Re: Spillway Modification

Diavik Diamond Mines (2012) Inc. (DDMI) is requesting approval for a modification to the Processed Kimberlite Containment spillway design. This request is made under Water License W2015L2-0001 Part G Item 2. DDMI notes for the Board that this request may require an associated Board approval for a revised freeboard limit as permitted under Part H Item 21a.

Attachment – Golder Technical Memorandum: Processed Kimberlite Containment Facility Operations Spillway Review

DATE October 2, 2015**GOLDER REFERENCE No.** 1521339-1419-TM-Rev0-4000**DIAVIK PO & WORK PLAN No.** PO#D03154 WP 452**TO** Gord Stephenson, Michael Bembeneck, and Andrew Oliver
Diavik Diamond Mines (2012) Inc.**CC** Adam Campbell, Troy Bortolotto, and Dan Guigon**FROM** James Ogilvie, Germán Pizarro, and
John Cunning**EMAIL** jogilvie@golder.com;
gpizarro@golder.com;
jcunning@golder.com**TASK DESCRIPTION** **PROCESSED KIMBERLITE CONTAINMENT FACILITY OPERATIONS SPILLWAY REVIEW**

Figure 2: PKC Facility Normal Operating Water Level and Freeboard Requirements

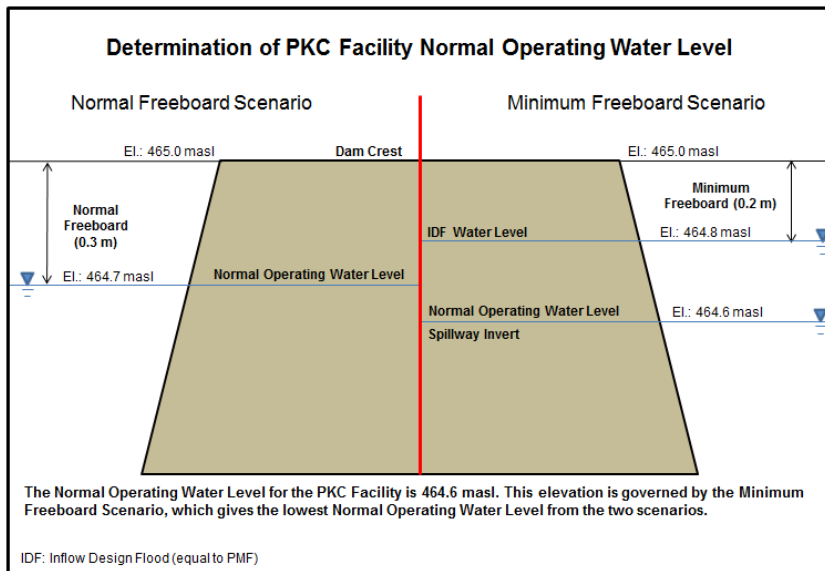
Figure 2 presents a visual comparison of the PKC Facility NOWL, as derived from the normal and minimum freeboard requirements. It can be seen that in this case, the minimum freeboard scenario governs.

DRAWING TITLE
PHASE 6 SPILLWAY PLAN, PROFILE AND CROSS-SECTIONS

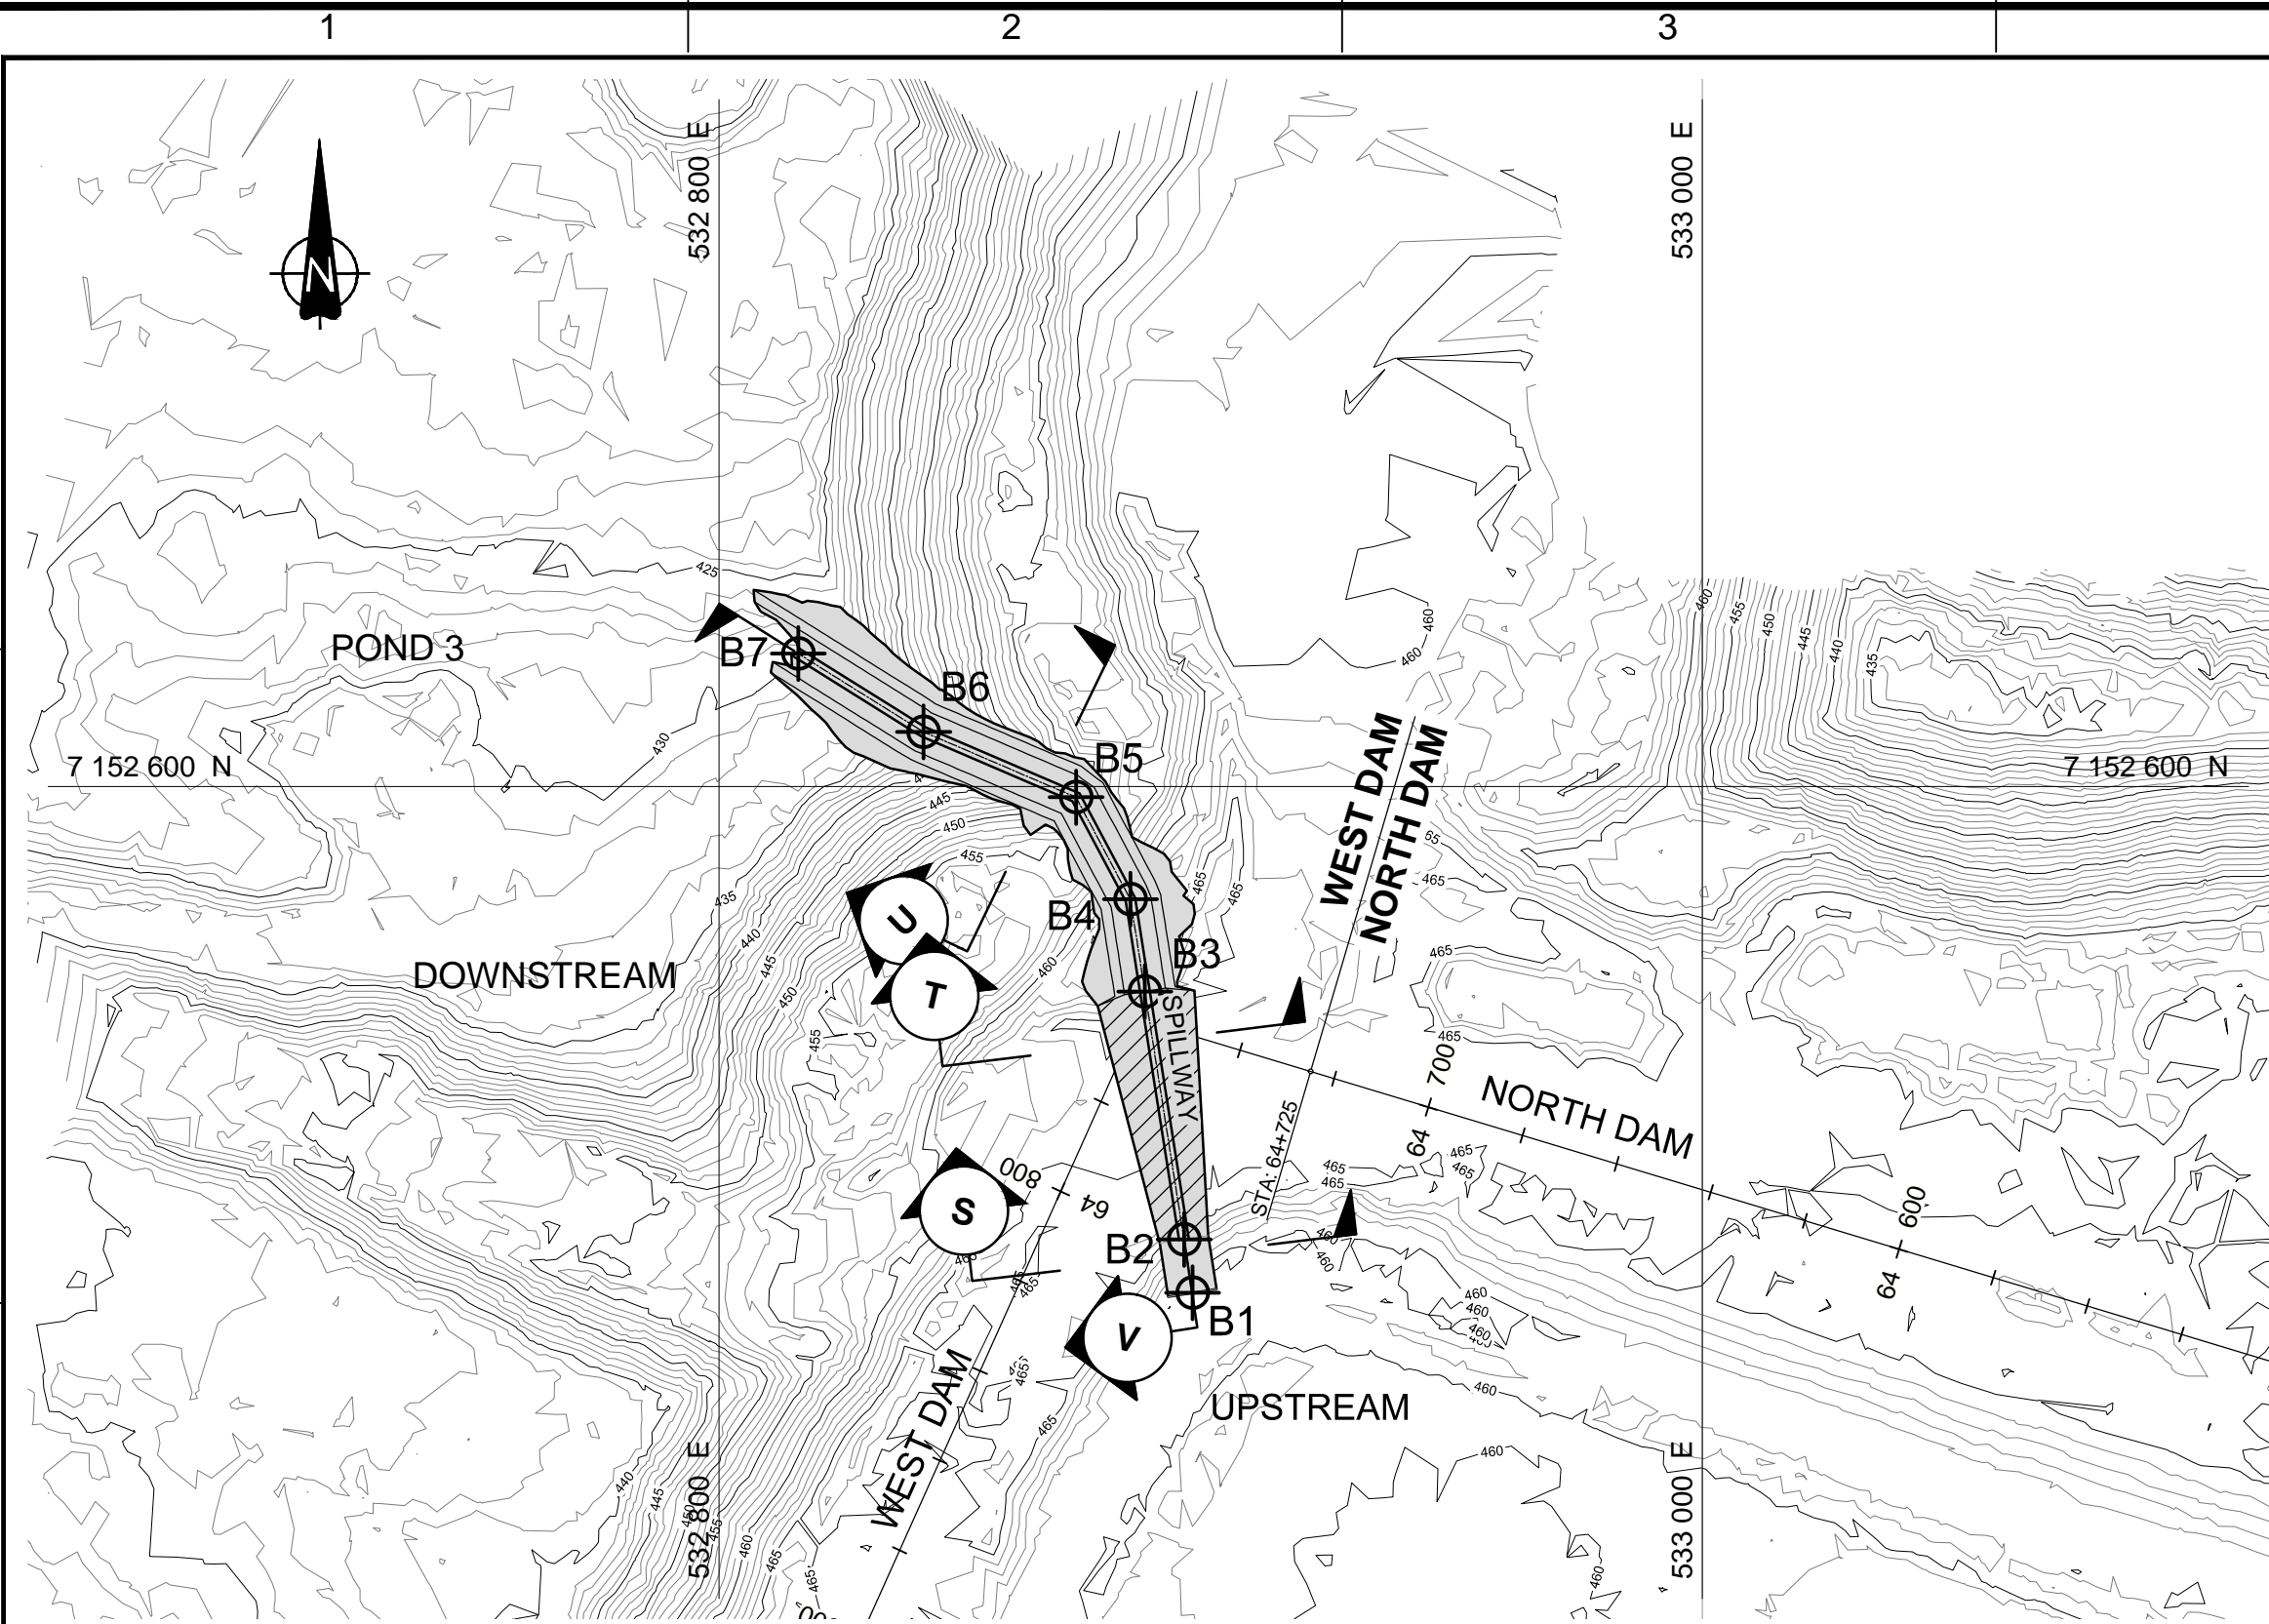
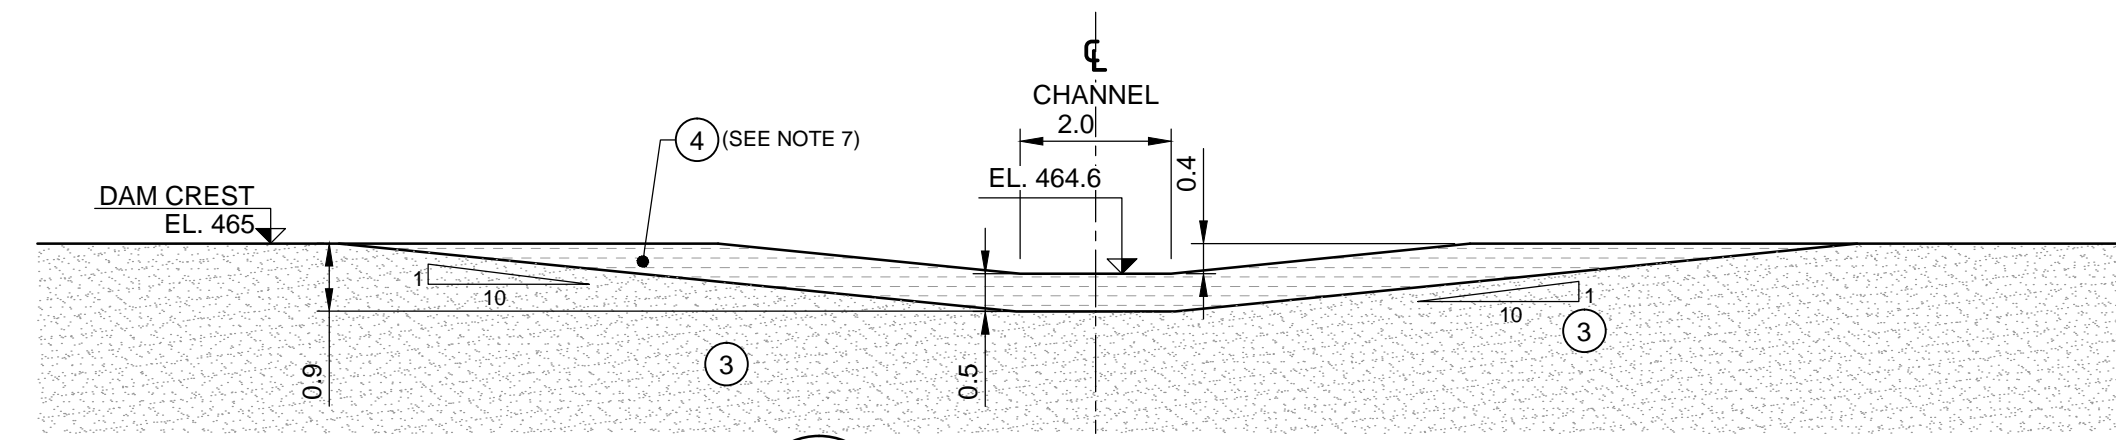
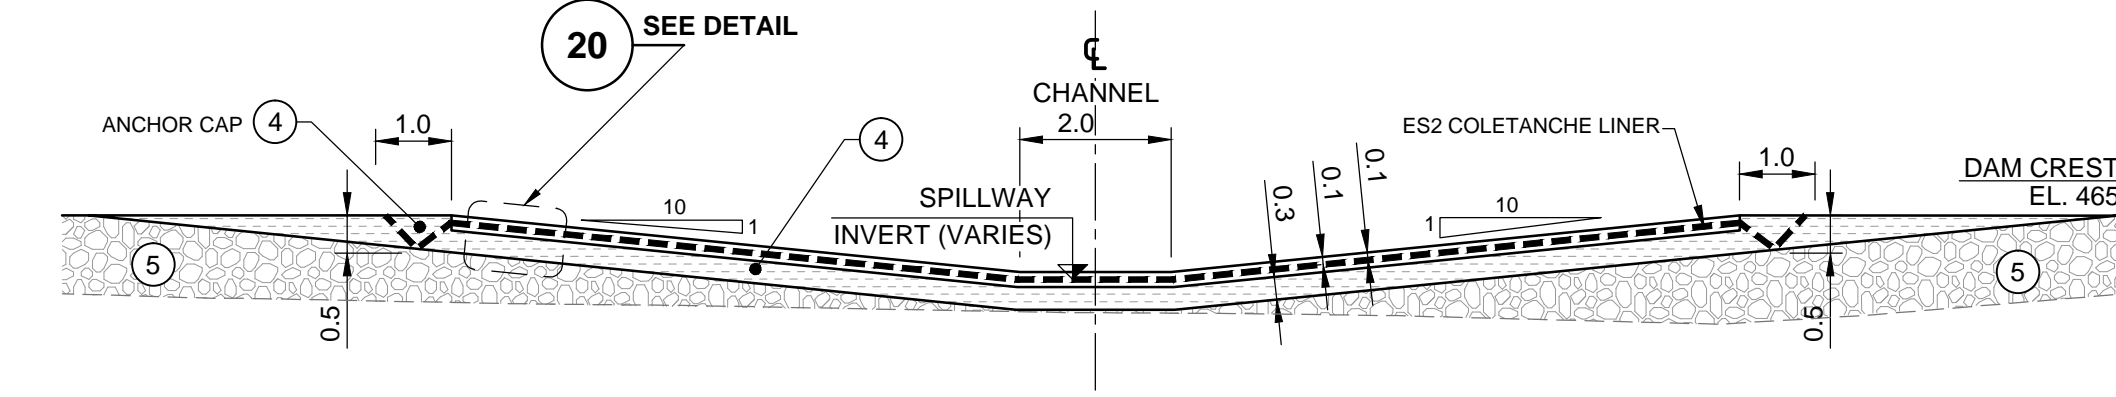
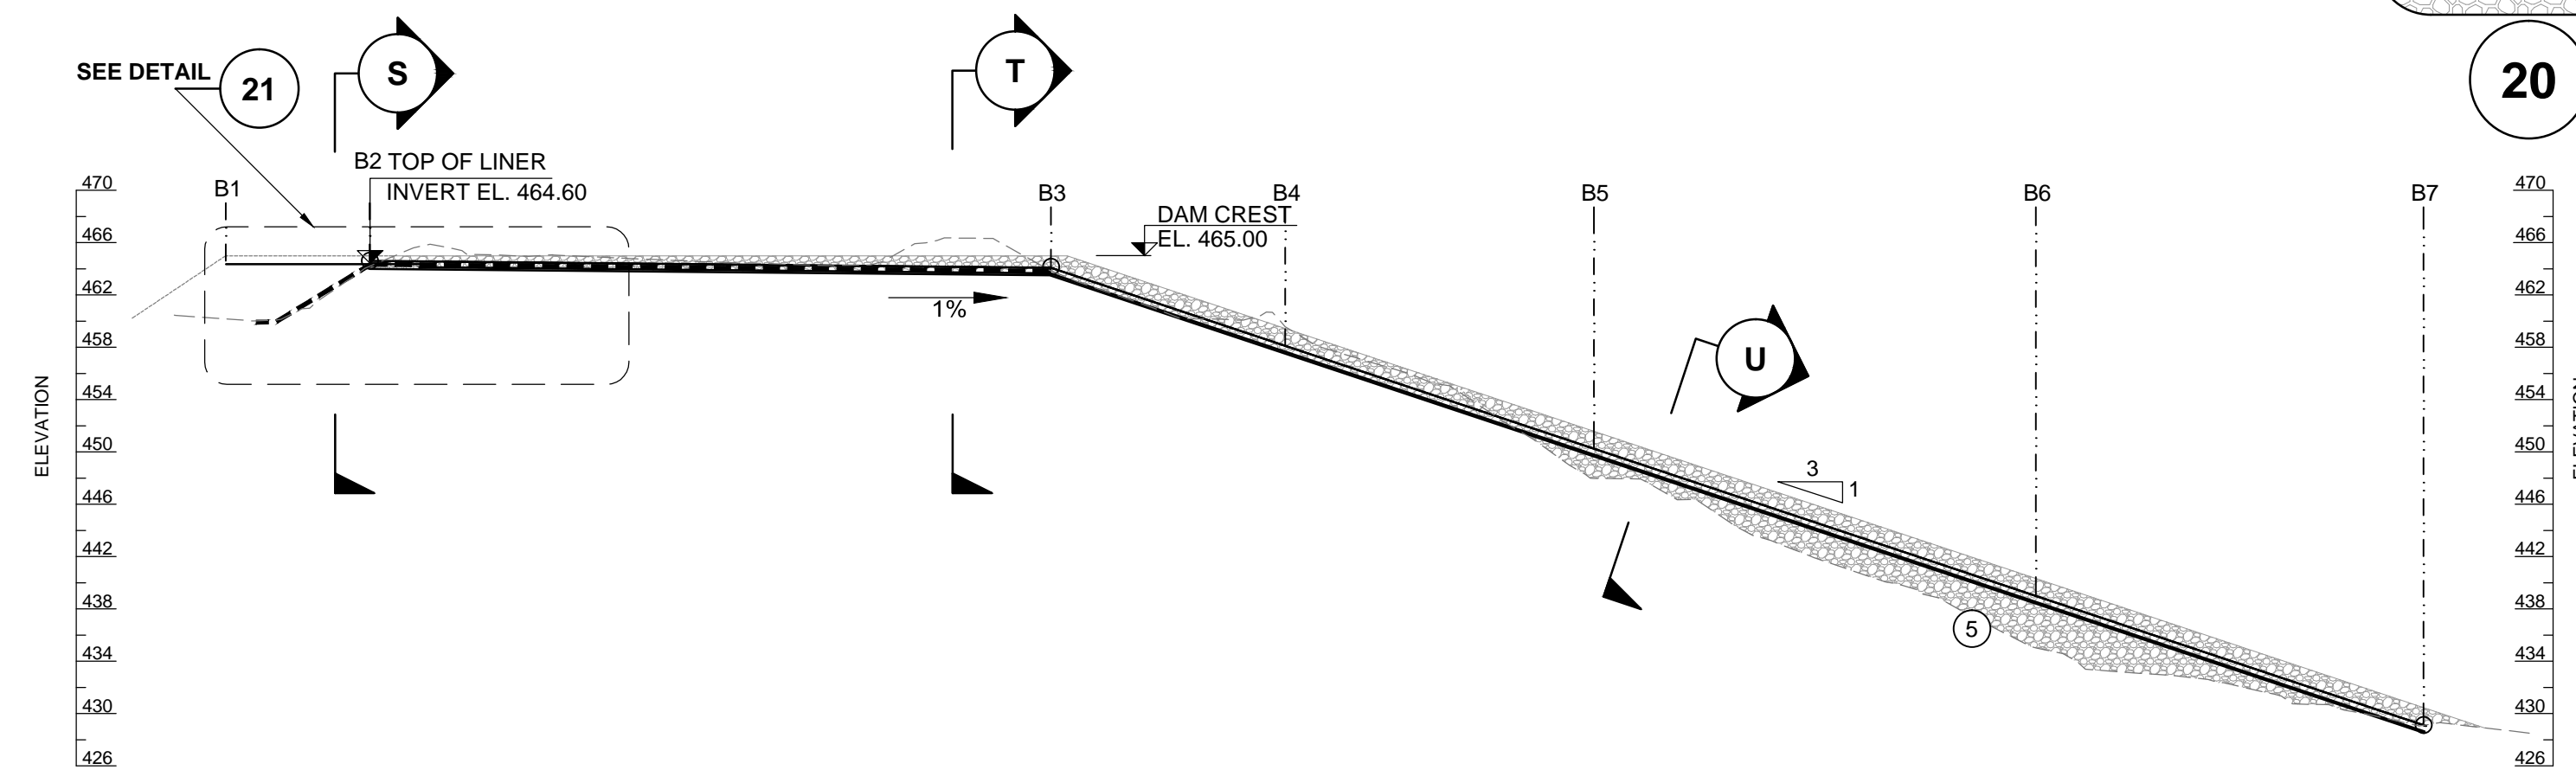
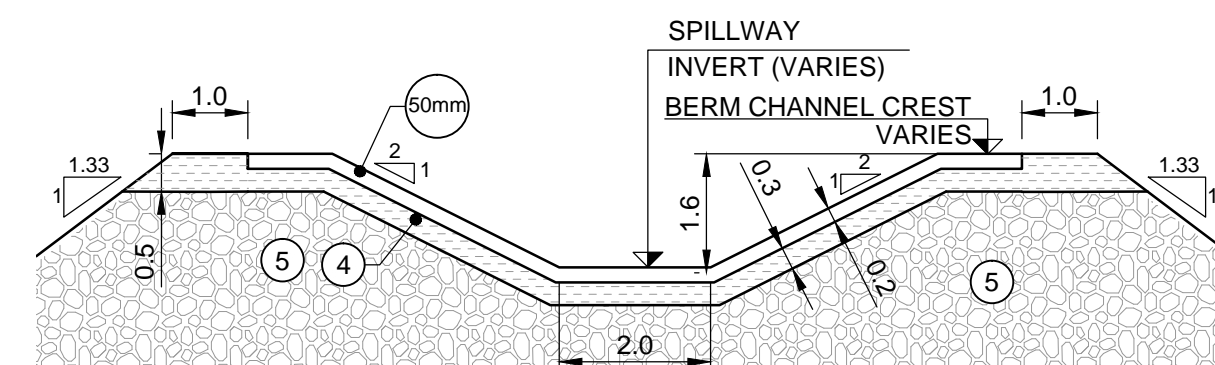
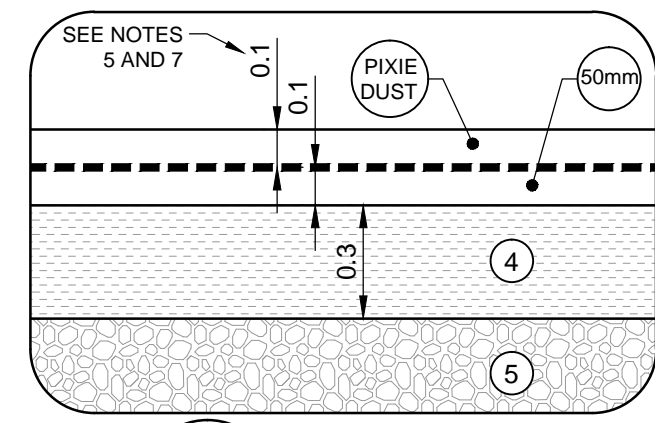
Golder has updated the Issued for Construction (IFC) spillway drawing 14111-41D1-6123 to show the updated spillway location and routing in the area where the North and West Dams meet, which would direct overflow, including the EDF and IDF, from the PKC Facility to Pond 3. This would require the Pond 3 spillway to be reviewed to confirm it can pass the same IDF as the PKC Facility. Review of the Pond 3 spillway is to be completed before the PKC pond exceeds an elevation of 463 m. The updated IFC spillway drawing 14111-41D1-6123 Rev 1 dated September 17, 2015 showing the spillway location is attached to this technical memorandum.

NOTE:
THE MODIFICATIONS TO THE SPILLWAY DESIGN PRESENTED IN THIS REVISION OF DRAWING 14111-41D1-6123 HAVE NOT BEEN INCLUDED IN DRAWINGS 14111-41D1-6100 TO 14111-41D1-6124. THE REVISION OF THIS DRAWING SUPERSEDES THE SPILLWAY DESIGN PRESENTED IN DRAWINGS 14111-41D1-6100 TO 14111-41D1-6124. THE SPILLWAY DESIGN PRESENTED IN DRAWINGS 14111-41D1-6100 TO 14111-41D1-6124 WILL BE UPDATED AS PART OF THE CONSTRUCTION RECORD PACKAGE.
